ADDENDUM NO. 1

Howe Company LLC

FOR: SHELBY COUNTY BRIDGE 11200041

BRO-R102(24)

SHEET 2 OF 32

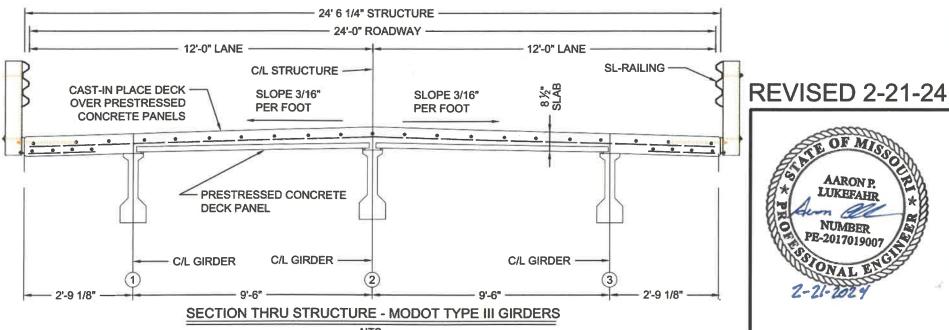
The piling shall be HP12x53, galvanized full length.

New Sheet 2. An updated sheet 2 (revised 2-21-2024) is issued with this addendum to replace the existing sheet 2 and provide consistency throughout the plans.

H-PILING, ASTM A709 (GRADE 50) FY=50,000 PSI (GALVANIZED) PER AASHTO M111/ASTM A123

H-PILING SHALL CONSIST OF HP12X53 ROLLED STEEL SECTIONS
